Technical Service Bulletin: tsb100872

New Lubricating Oil Pumps

This Technical Service Bulletin announces the release of new lubricating oil pumps for use on QSK45, QSK60 and QSK78 series engines.

Table 4: QSK78 Lubricating Oil Pump Rebuild Parts

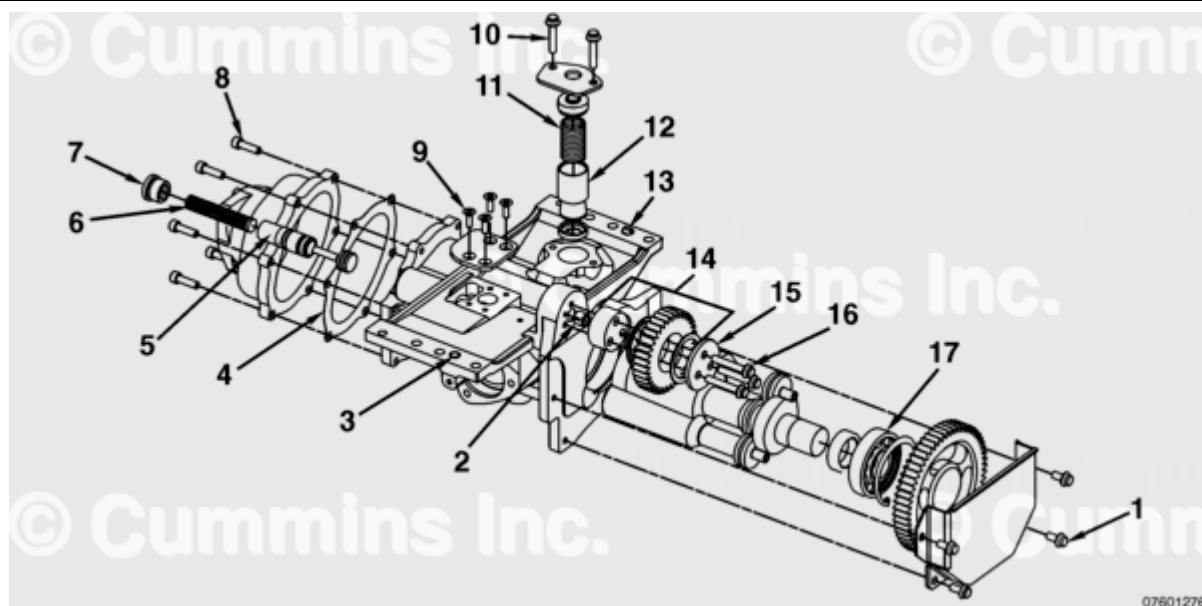
The new lubricating oil pumps have had the internal oil passages revised to allow the lubricating oil pump idler gear bushing to be supplied with filtered oil, increasing the durability of the pump. The new lubricating oil pump part numbers are shown in Table 1.

Some QSK45 and QSK60 engines were built with lubricating oil pumps similar to the one shown above, but which did **not** contain a high pressure relief valve. The lubricating oil pumps which did **not** contain high pressure relief valves are, Part Numbers 4100710 (QSK45) and 4100711 (QSK60). All parts, except for the high pressure relief valve components, used in these pumps are the same as those shown in Table 3.

If an engine has a pump that does **not** have a high pressure relief valve, it is recommended that the pump be replaced with one that does.
